MEMORANDUM

To: The Design Advisory Board
From: Mary O'Neil, AICP, Principal Planner
RE: 159 Locust Terrace, ZP18-0857CA
Date: April 24, 2018

File: 18-0857CA
Location: 159 Locust Terrace
Zone: RL **Ward:** 5S
Parking District: Neighborhood
Estimated Construction Cost: \$200,000
Date application accepted: April 3, 2018
Applicant/ Owner: Norman Benoit / William Marquess / Terry and Pat Rivers
Request: Renovation and addition to existing single family residence.

EXISTING/ PROPOSED
SITE PLAN

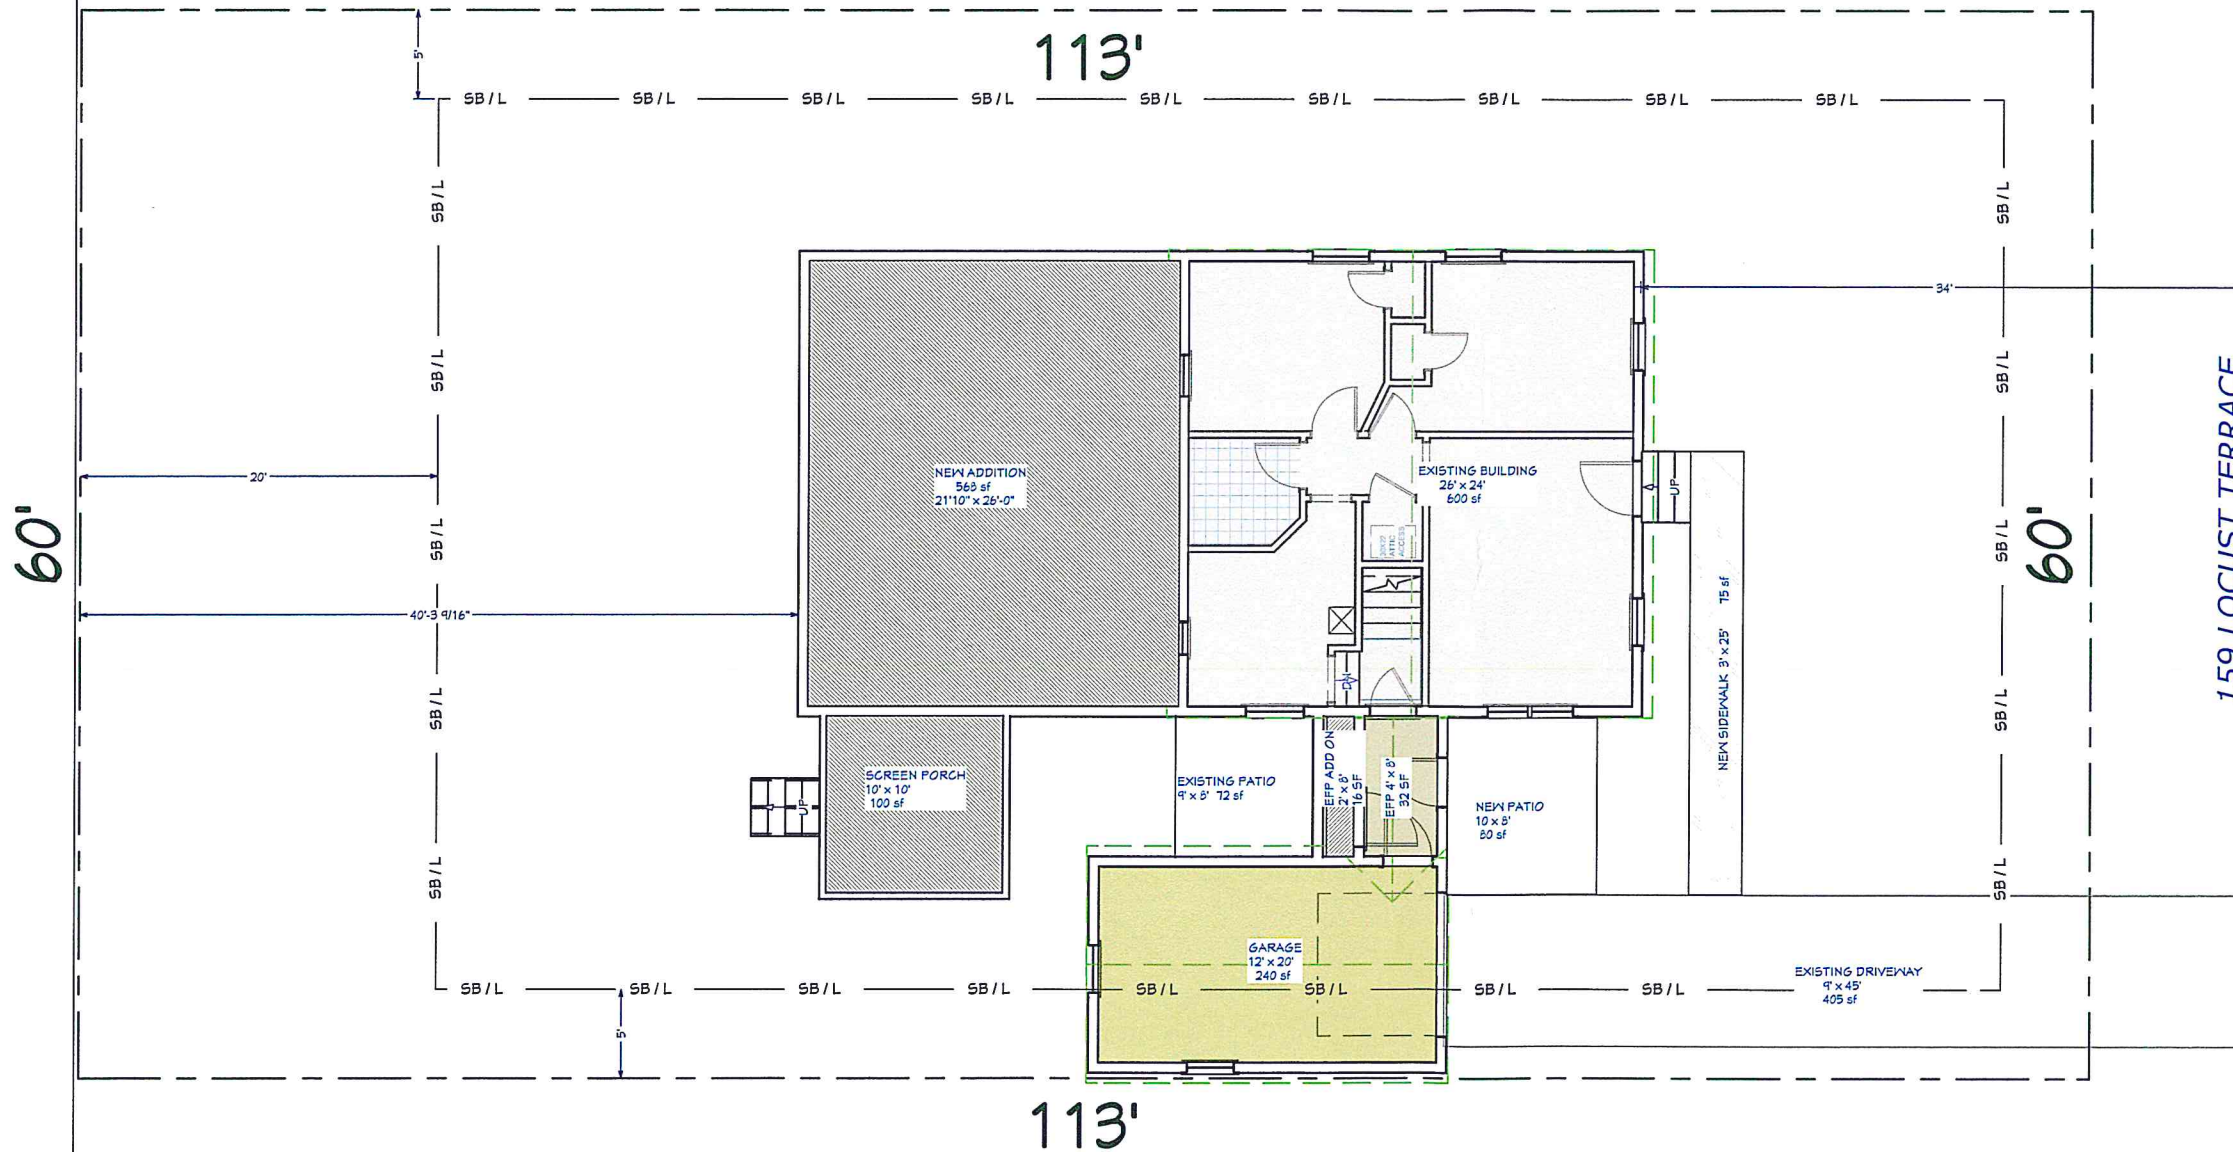
A new walkway will be added to address the traditional front door from the driveway. An entry patio at the mudroom will direct guests and residents to that improved entry.

The application defines installation of HVAC, but an exterior condensing unit is not illustrated on the site plan. If proposed for exterior installation, it must be identified on the site plan; it must observe required setbacks; and be screened from view or located away from the principal façade of the building.

1. Include a walkway strip connecting the new pergola to the new walkway that connects the driveway to the front door
2. If an HVAC is used it shall be located in the alcove between the garage and the screened porch.
3. Landscaping shall be added at the northeast corner to screen the utility meters.

SHEET TITLE: **NORTH
ELEVATION**

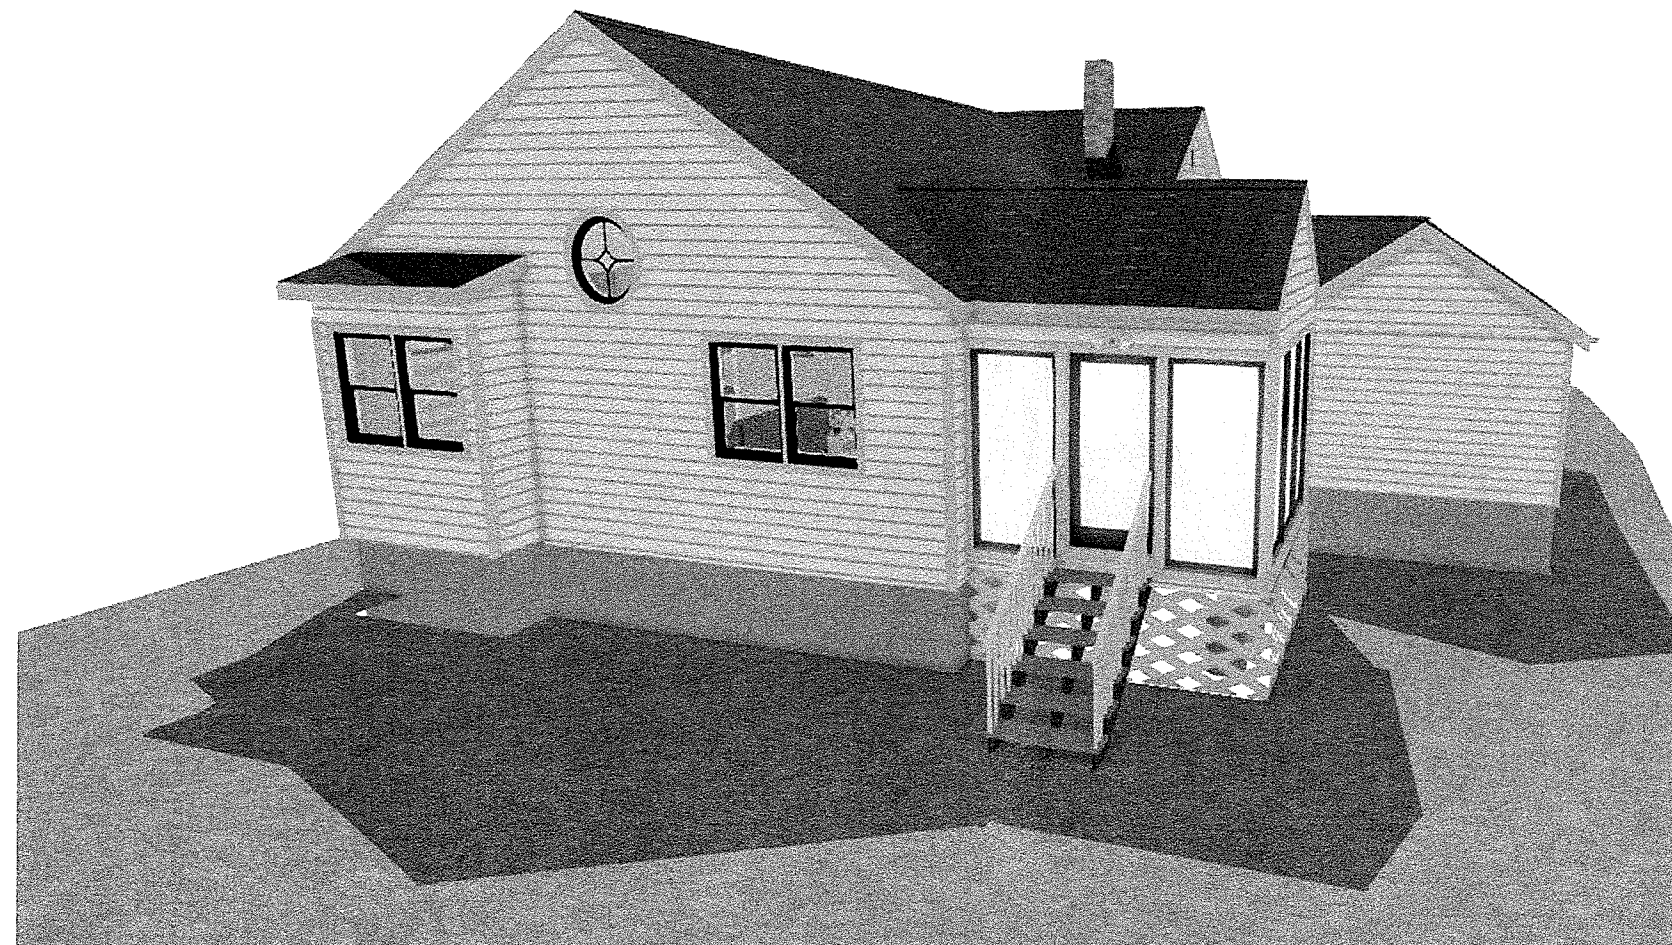
No landscaping plan has been provided; however, the new building mass is proposed behind the existing residence and will not demand any screening. The gas and electric meters are on the north elevation, but it appears that existing landscaping on the lot obscures their view from the public way. If the large tree in the front yard is removed, planting to screen their visibility is recommended.

Electric and gas meters are currently on the north elevation and are proposed to remain. A large tree in the front yard currently obscures most of the building. If the tree is to be trimmed or removed, some form of screening is recommended to reduce the visibility of these utility connections. Hotwater heater vent and furnace vent are proposed for the south elevation, obscured by the new mudroom/garage. The microwave vent will be behind the gable of the mudroom; similarly hidden from street view. A dryer vent and fireplace vent are located on the north elevation; sufficiently set back from the building's façade so as to minimize visibility.

View of front elevation looking easterly.

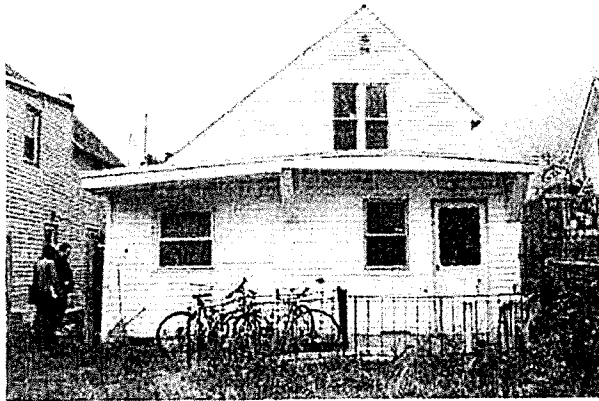
The molded cornice is one of few remaining historic elements.

Rear elevation, showing non-historic rear addition.

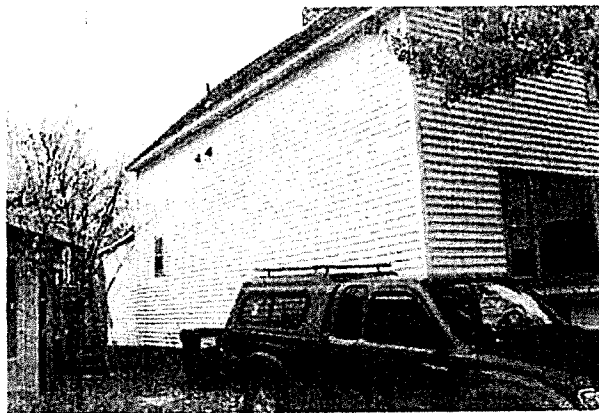
The north elevation has only 1 window, most likely others were removed or covered over.
